Rezoning Application: PD 21-1329
Zoning Hearing Master Date: February 14, 2022
BOCC Land Use Meeting Date: April 12, 2022

Applicant: Nick Brackin – Brackin Renovations & Development LLC
FLU Category: RES-9
Service Area: Urban
Site Acreage: 1.899
Community Plan Area: Seffner Mango
Overlay: None

The applicant proposes to rezone the subject property from AS-1 to PD to allow for 17 multi-family units.

8.0 PROPOSED SITE PLAN (FULL)

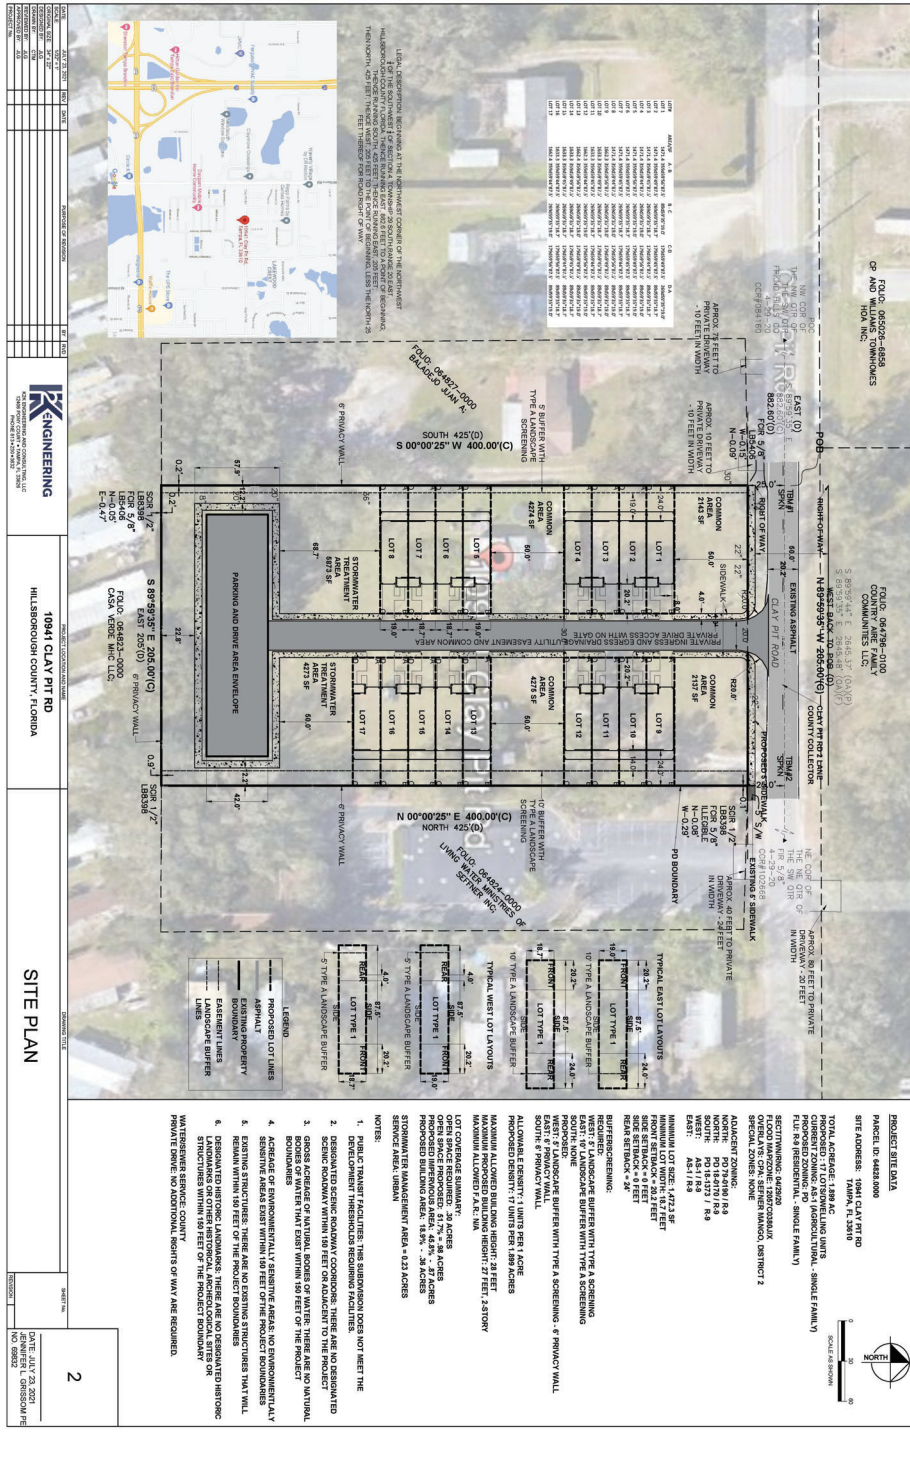
1. Typical West Lot Layouts to show correct rear yard of 19 feet, not 4 feet.
2. Add a note to the site plan that states "Sidewalks shall be provided in accordance with the Hillsborough County LDC."
3. Add a note to the site plan that states "Parking shall be provided in accordance with the Hillsborough County LDC."

Figure 1.

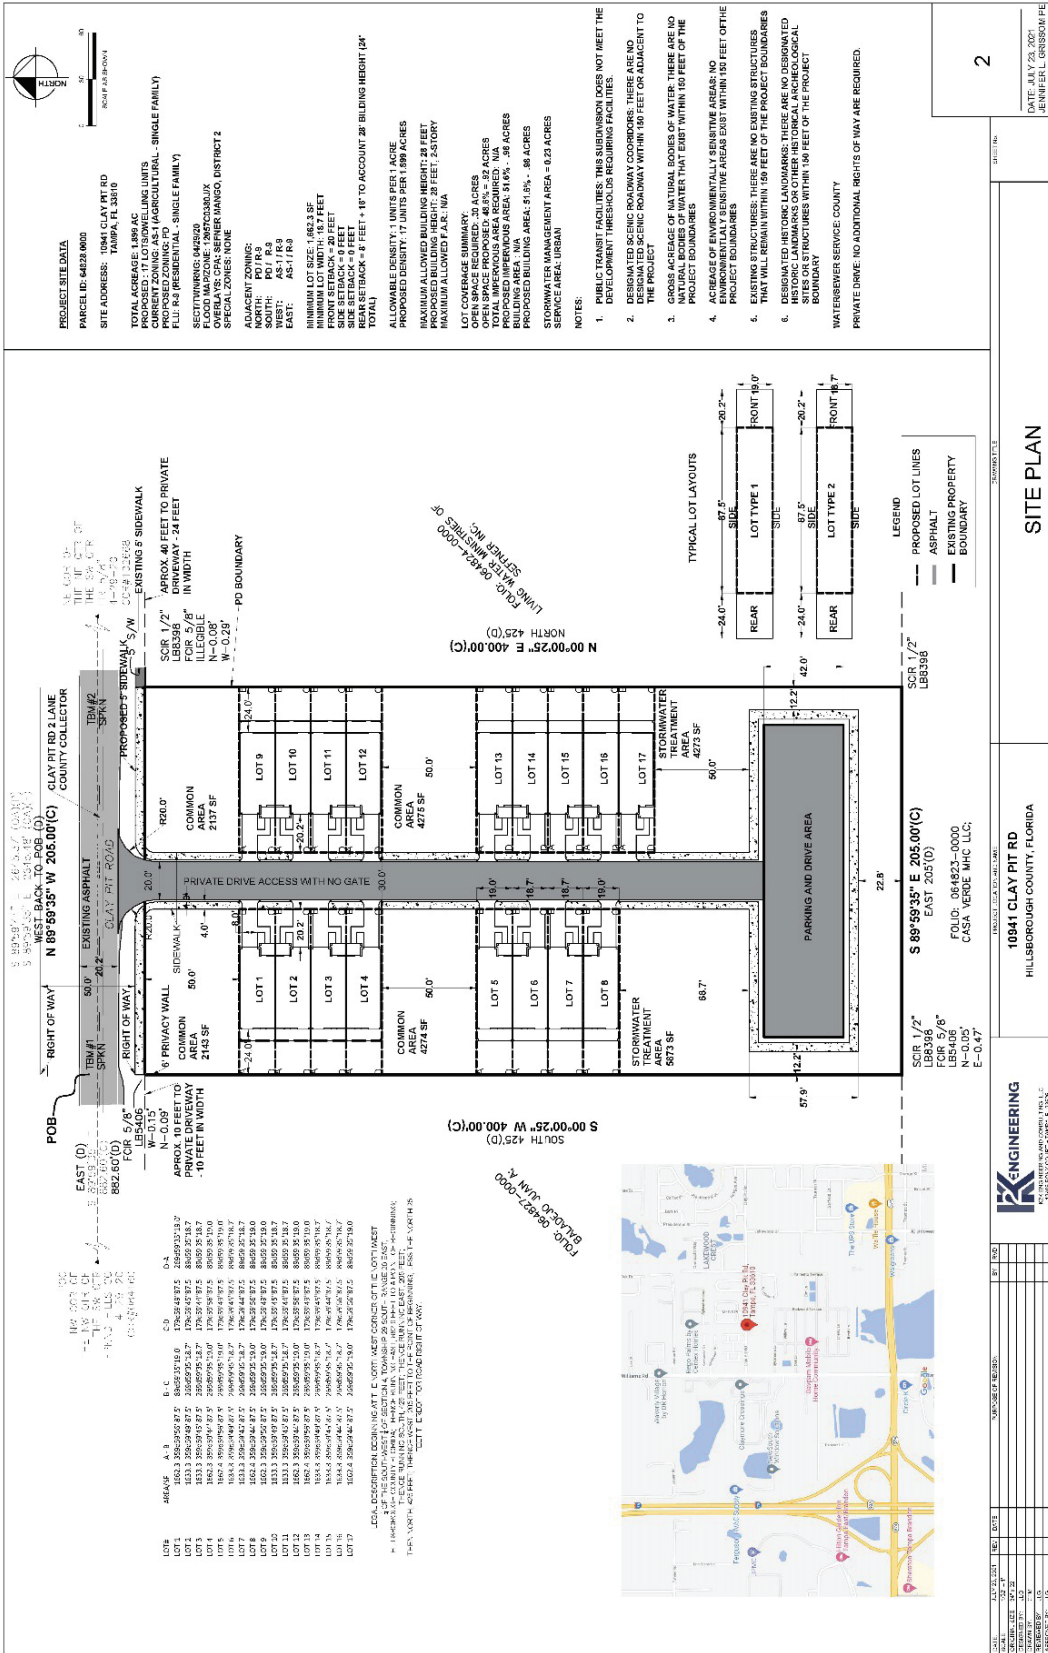
The request is for Administrative Variance to Section 6.04.07 of the Hillsborough County LDC for the access spacing on Clay Pit Rd. Based on Section 6.04.07, the access spacing for Clay Pit Rd is 330 feet. The spacing for access is 90 feet from the driveway to the west and 135 feet to the driveway to the east. This is geographically shown in Figure 1.

5. A 6 foot high wall shall be provided along the entire southern PD boundary, as depicted on the site plan.
6. If PD 21-1329 is approved, the County Engineer will approve a Section 6.04.02.B. Administrative Variance from the Section 6.04.07 access spacing requirements (dated November 30, 2021) which was found approvable by the County Engineer (on December 2, 2021). Approval of this Administrative Variance will permit the reduction of minimum access spacing between the project driveway and next closest driveway to the west to +/- 90 feet and +/- 135 feet to the driveway to the east.

Figure 1.

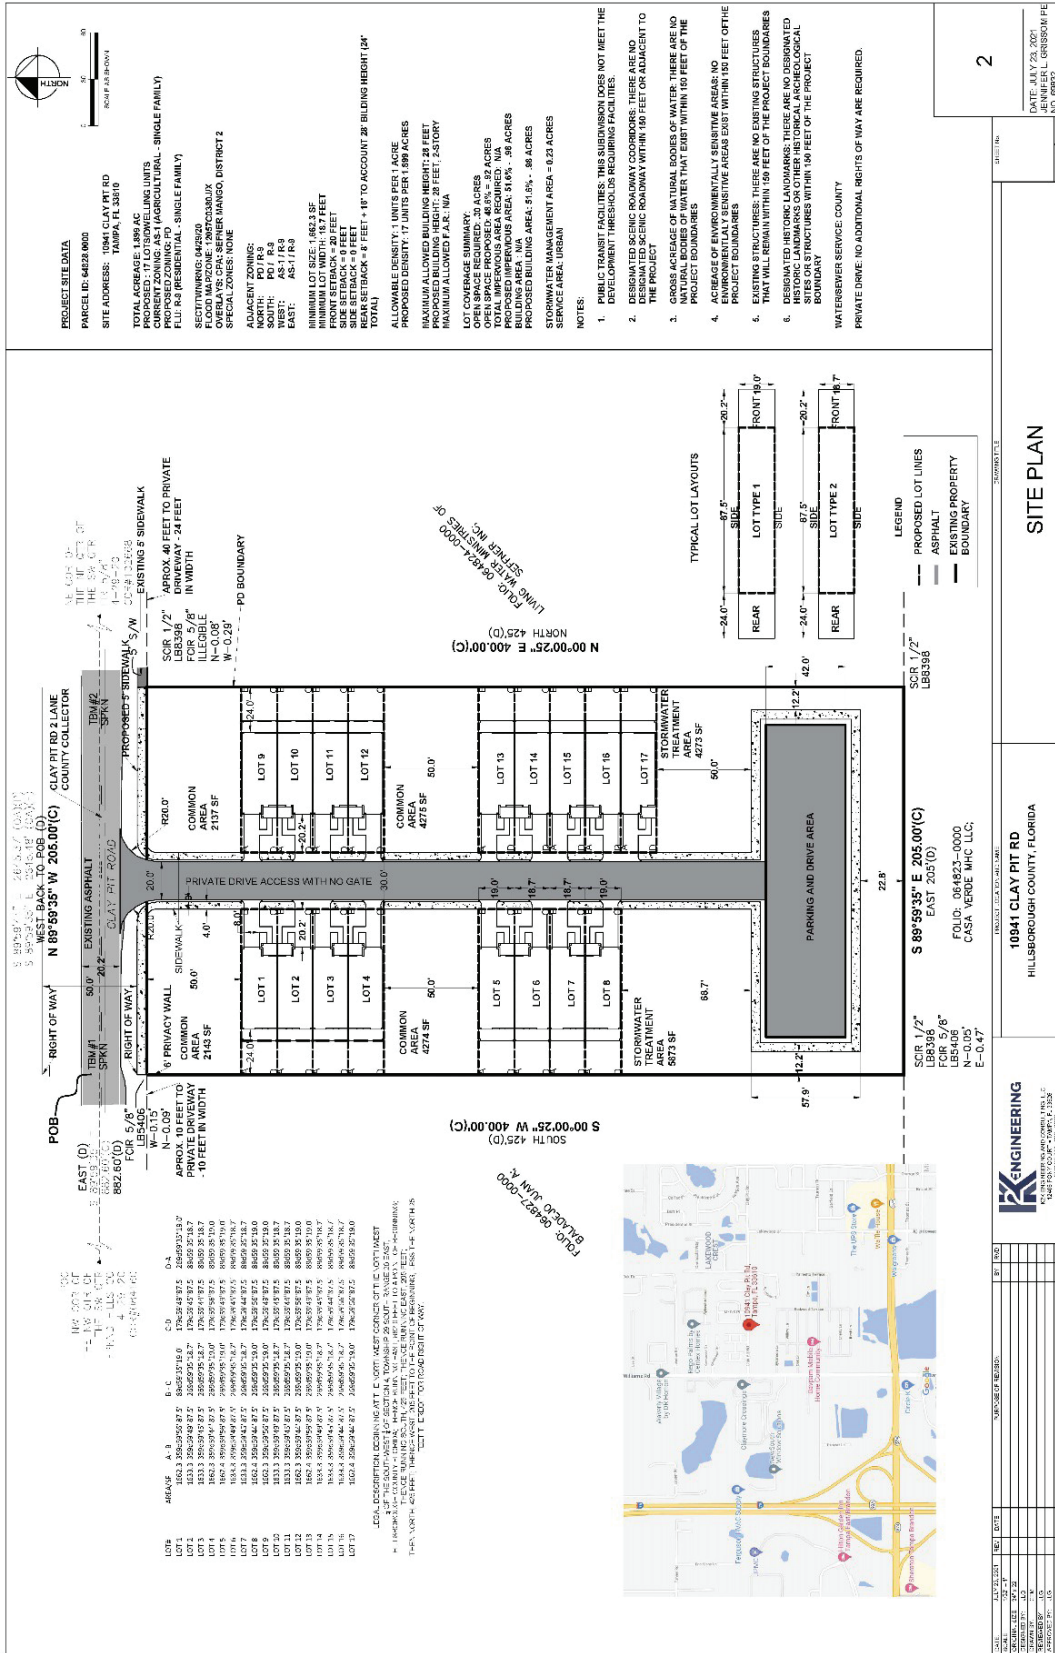
The request is for Administrative Variance to Section 6.04.07 of the Hillsborough County LDC for the access spacing on Clay Pit Rd. Based on Section 6.04.07, the access spacing for Clay Pit Rd is 330 feet. The spacing for access is 90 feet from the driveway to the west and 135 feet to the driveway to the east. This is geographically shown in Figure 1.
